THE CITY OF SAN DIEGO TO THE PARK AND RECREATION BOARD

REPORT NO: 102

SUBJECT: Wegeforth Elementary School Joint Use Park - General Development Plan.

SUMMARY: Should the Park and Recreation Board approve the proposed General Development Plan (GDP) for Wegeforth Elementary School Joint Use Park?

**WEGEFORTH JOINT USE PARK
RESTROOM PLANS**

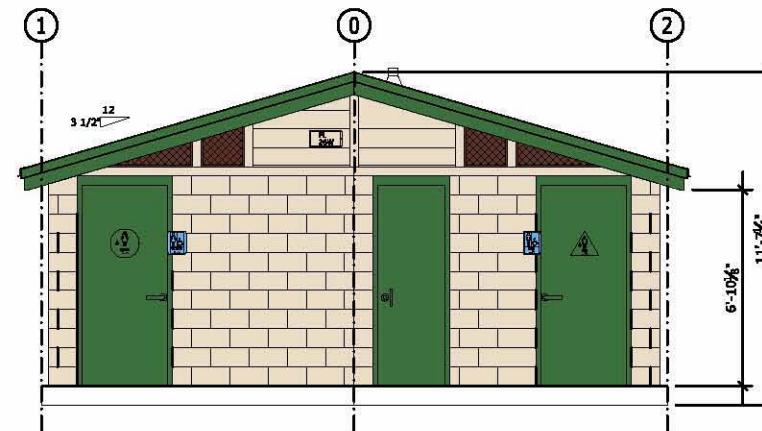
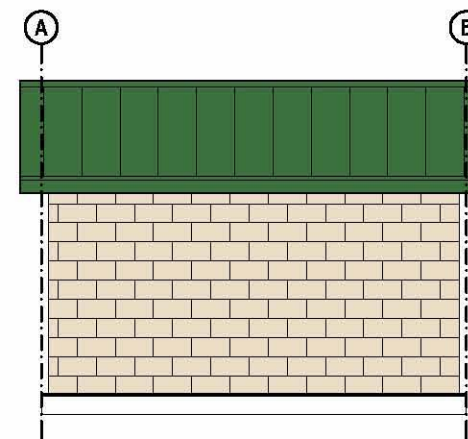
- The comfort station interior design needs further study to address sight lines into the restroom.
- Study the turn-around at the west end of the parking lot to see if there is a better way to address vehicle navigation when the parking lot is full.
